City of Alexandria, Virginia

MEMORANDUM

SUBJECT: UPDATE ON PERMIT TO DEMOLISH, ADDITION AND ALTERATIONS
AT 207 PRINCE STREET, BAR CASE #2013-0066 & 0067

Physical Investigation and Documentation of the Fairfax–Moore–Montague House Kitchen

NEW FIRST FLOOR PLAN 1/4"=1'-0"

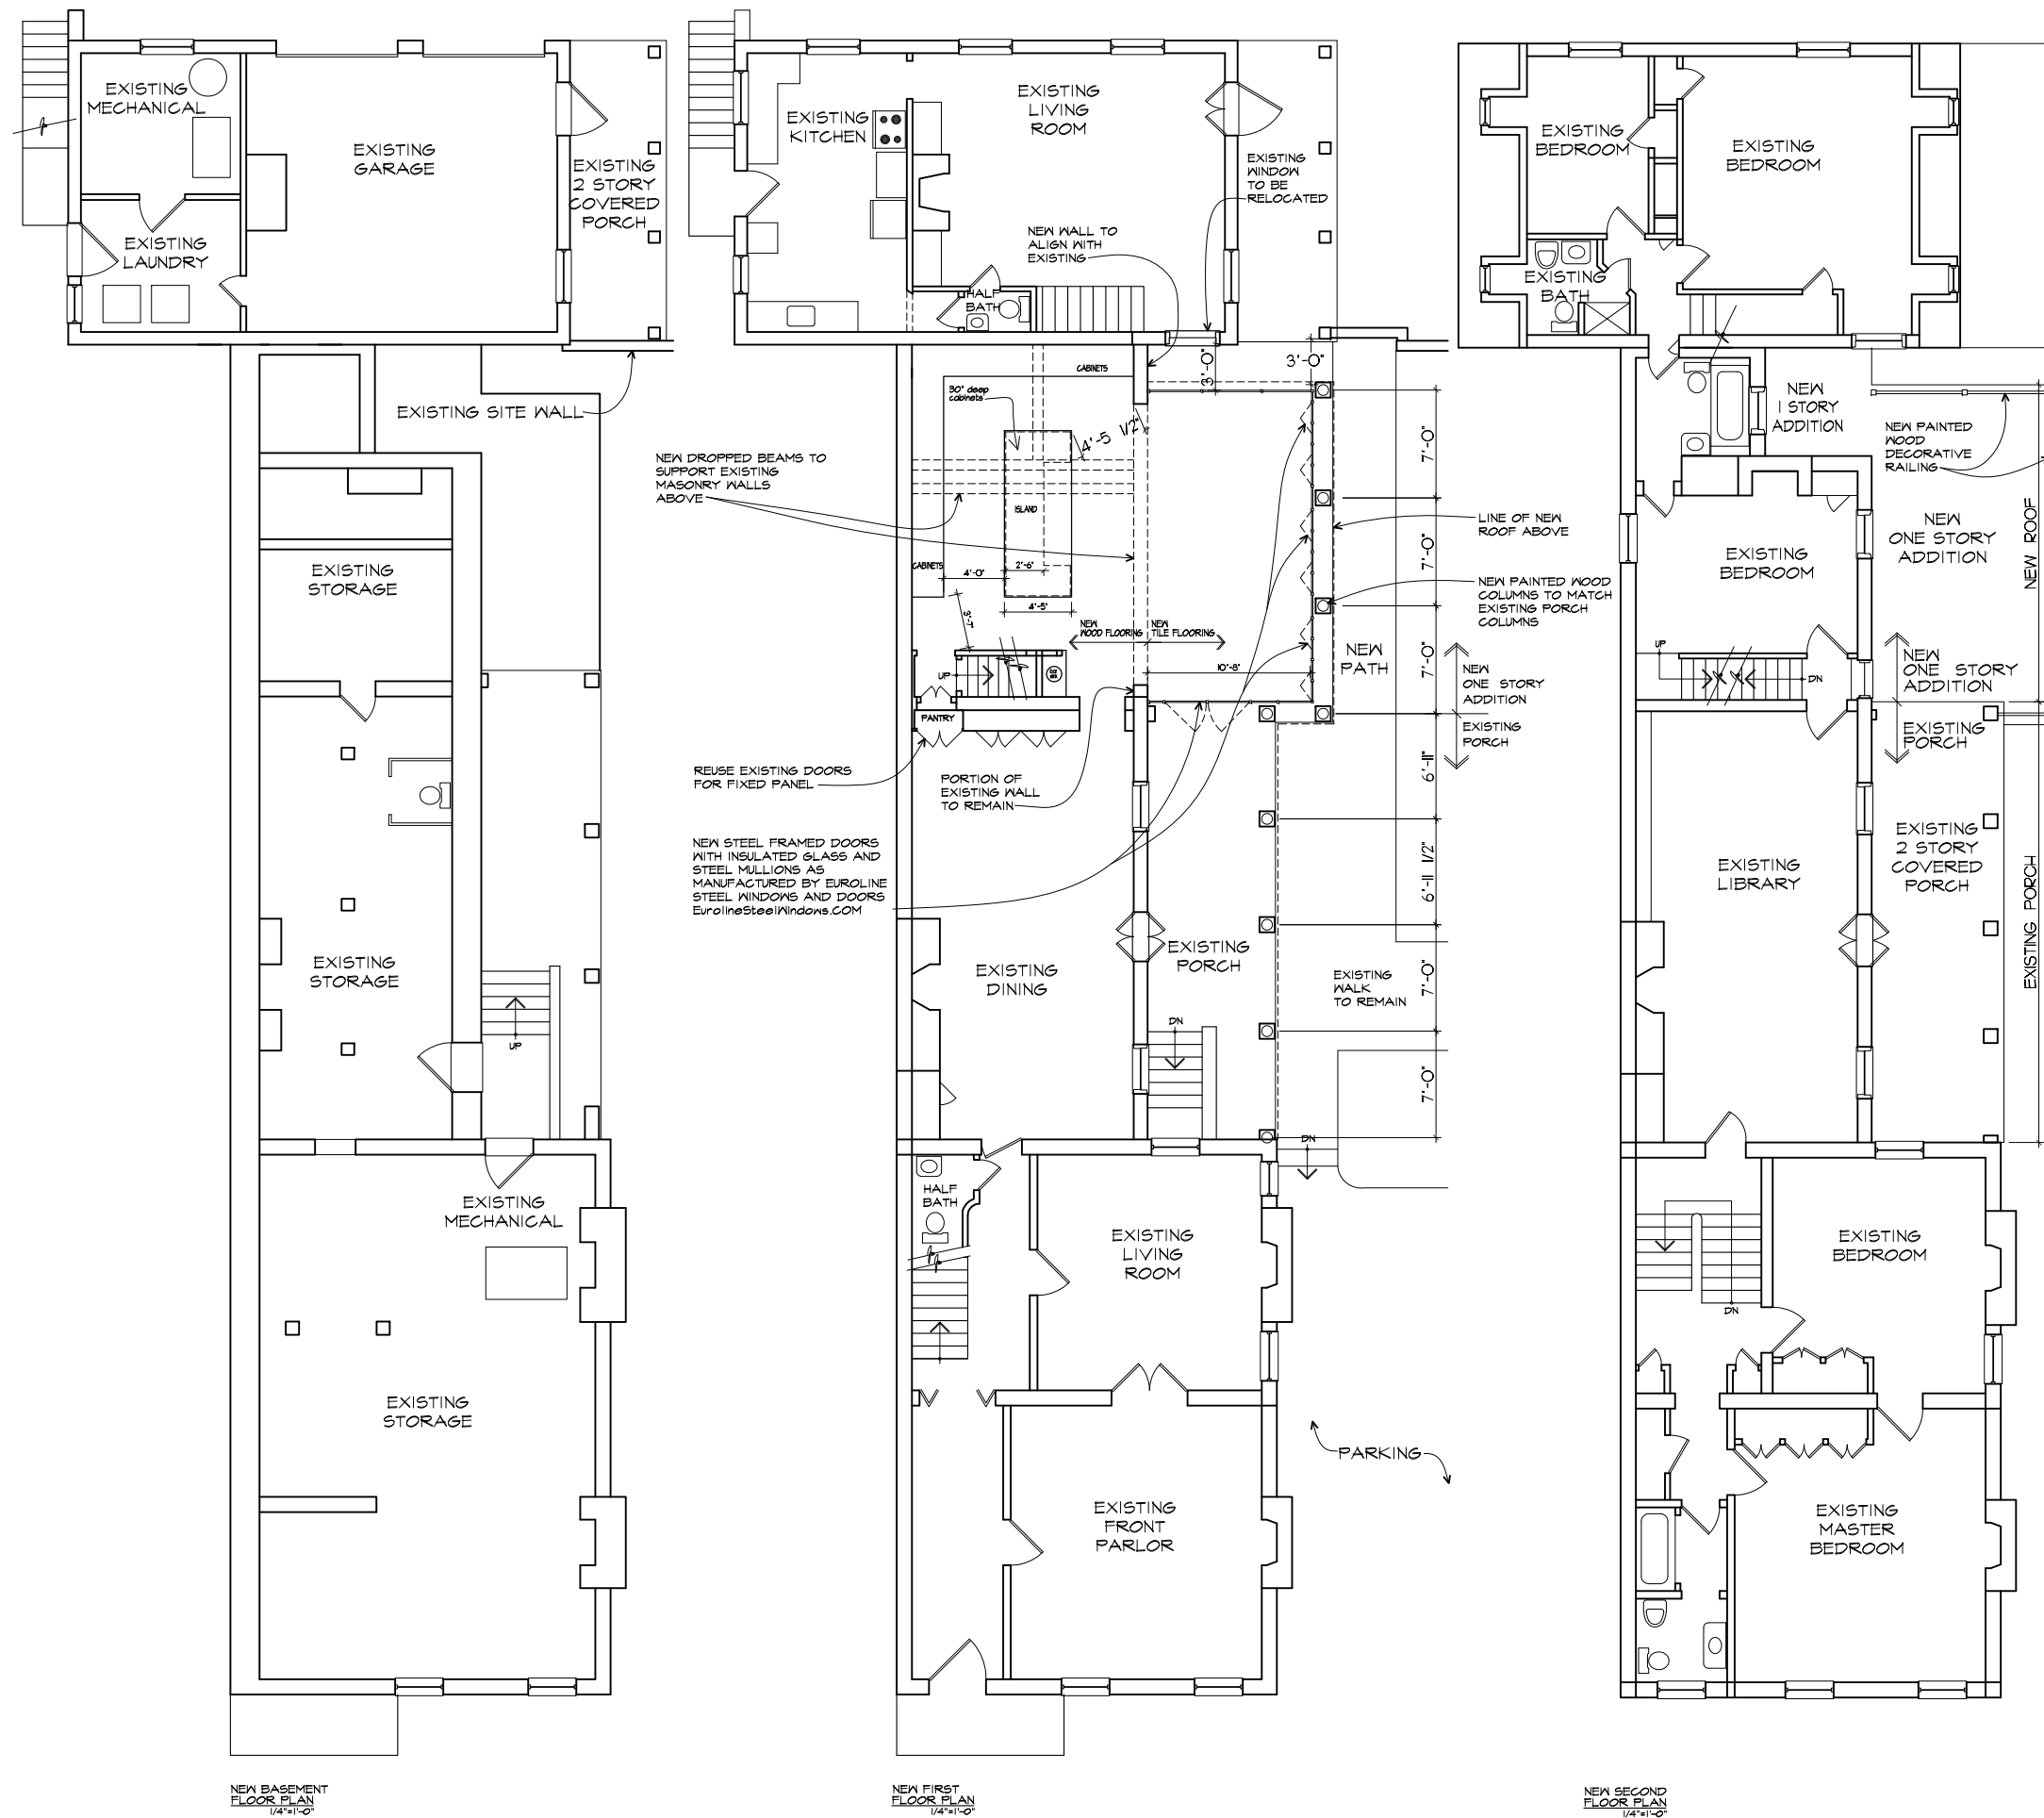
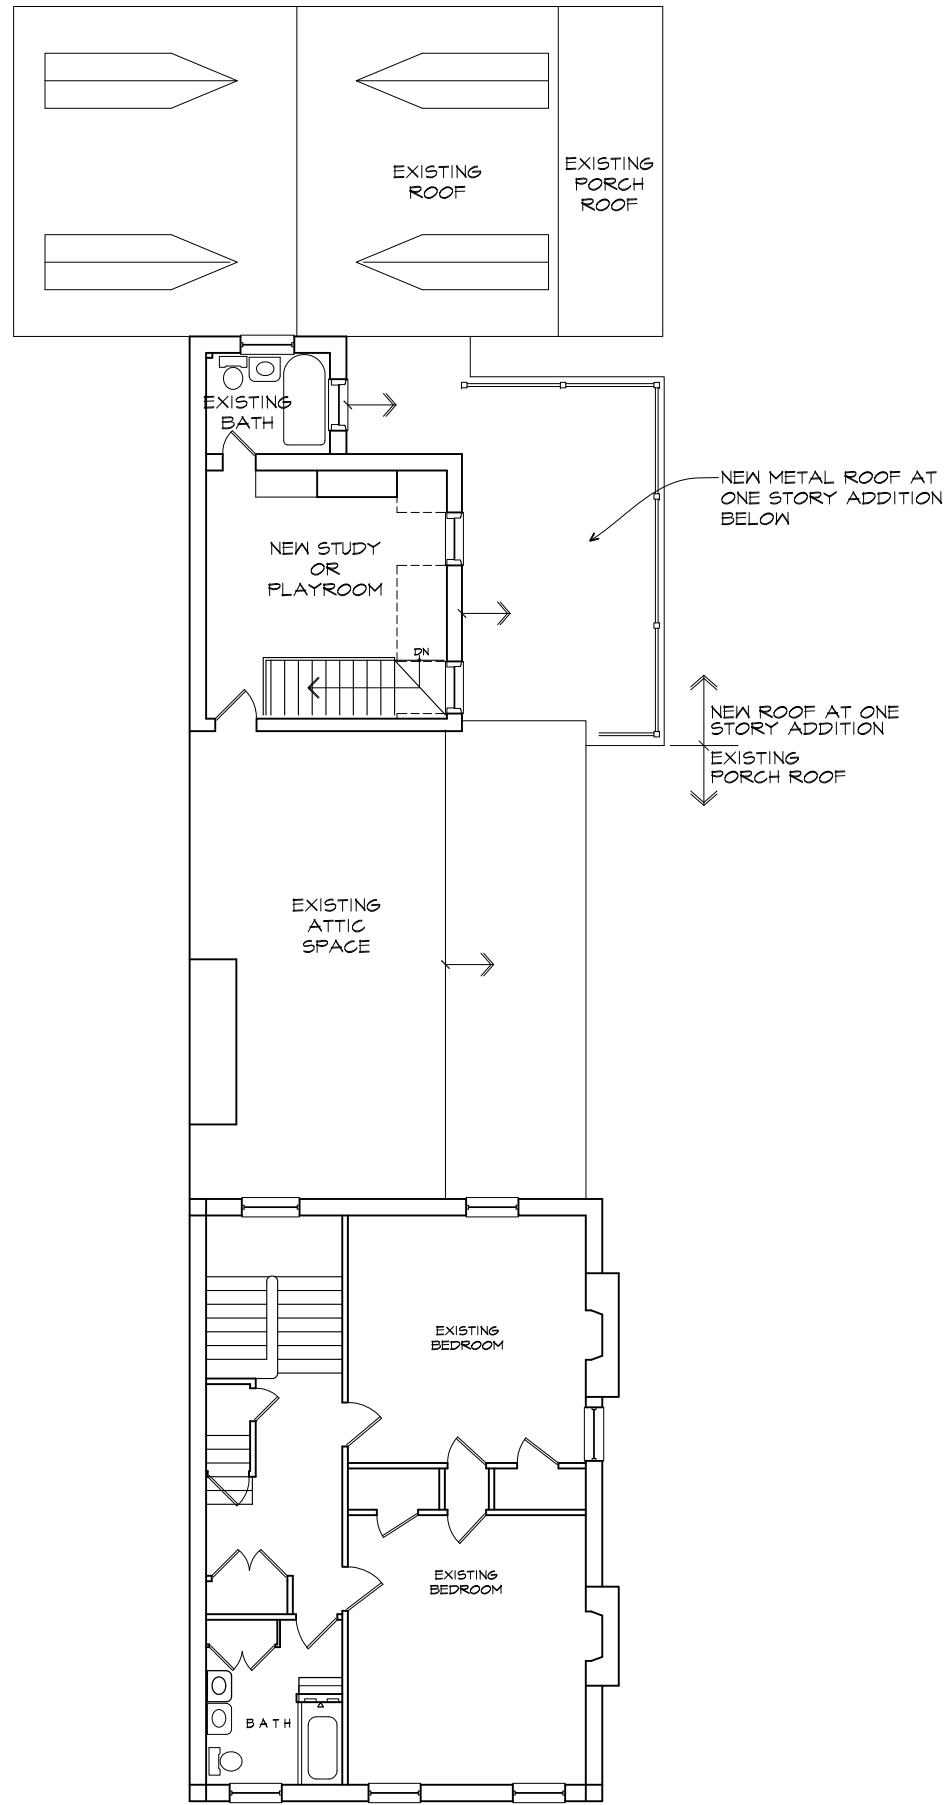
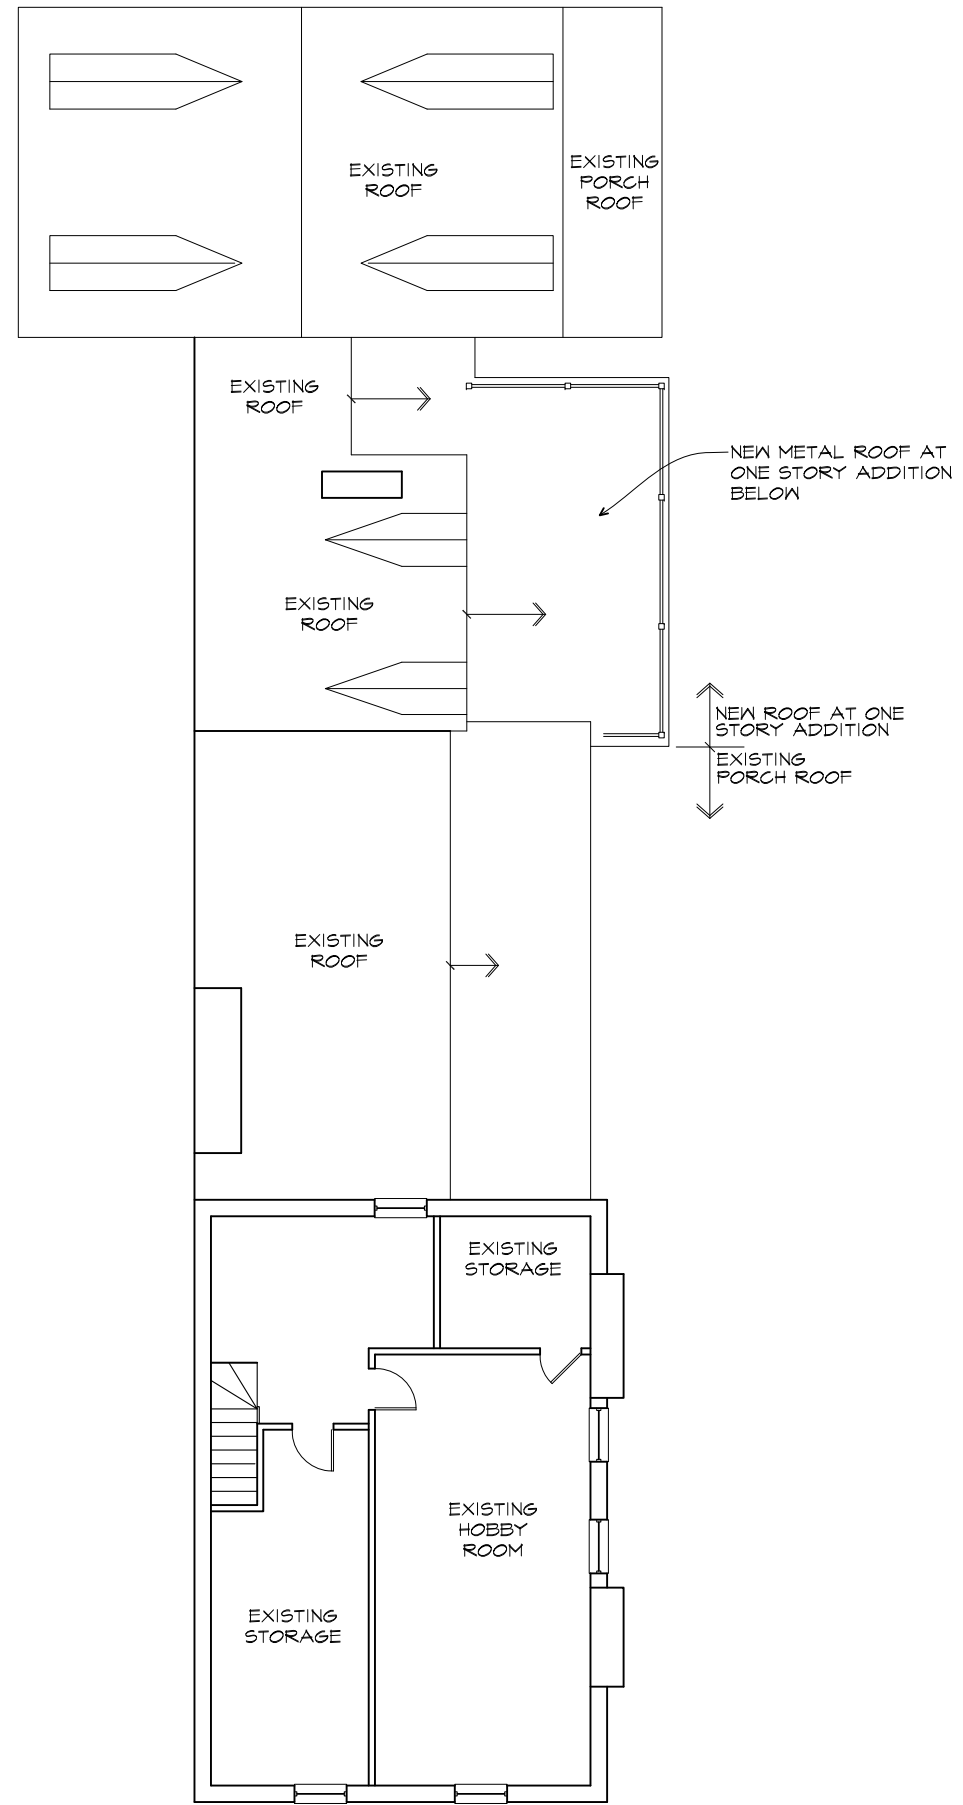
Staff finds that both Criteria 3 and 5 are met and a Permit to Demolish should not be granted for the chimney, firebox, and the majority of the north masonry wall, as these are uncommonly old and unusual in design. Aside from the fact that the 18th century materials and workmanship of the north wall and hearth could not easily be reproduced, once the proposed demolition is completed, the applicant proposes to install steel beams to support the second and third stories which will make future restoration of the firebox and north wall virtually impossible. Additionally, the proposed addition and alterations will require significant structural footings to support the remaining two story masonry building above, making it difficult to preserve the currently intact cellar walls, foundation, fireplace base and arch (of which the fireplace base and arch are identified by the consultant as authentic and unusual). The prominent location of this house on Gentry Row, its individual National Register historic listing in 1991, and its relevance to the history of preservation in Alexandria strongly support the need to preserve this historic building for the interest of the city.

Based on the additional archival and field research performed since the June 19, 2013 staff report, including the consultant's concurrence that the chimney and firebox are original and relatively intact, staff finds these elements to be essential character defining features of the 18th century kitchen. Therefore, staff recommends that the firebox and a majority of the masonry north wall be preserved to reflect the original masonry form of the kitchen. Staff has no

objection to removal of a majority of the east kitchen wall on the first floor, as this wall has clearly been altered several times and has lost much of its historic integrity. In addition, the simple east brick wall with its 20th century windows is not kitchen-specific or an unusual architectural feature. Staff also supports the proposed family room expansion into the garden on the east side and capsulation of the first floor of this portion of the building with the following conditions.

1. **Denial** of demolition/capsulation of the 18th century chimney, firebox and majority of the masonry north wall of the existing kitchen.
2. **Approval** of demolition/capsulation of the majority of the east wall, with a minimum of 12” of brick to remain in the corners of the room at each end of the wall and below the finished ceiling.

8. **Approval** of the proposed exterior walls of the kitchen/family room addition, as shown on the drawings dated June 19, 2013.
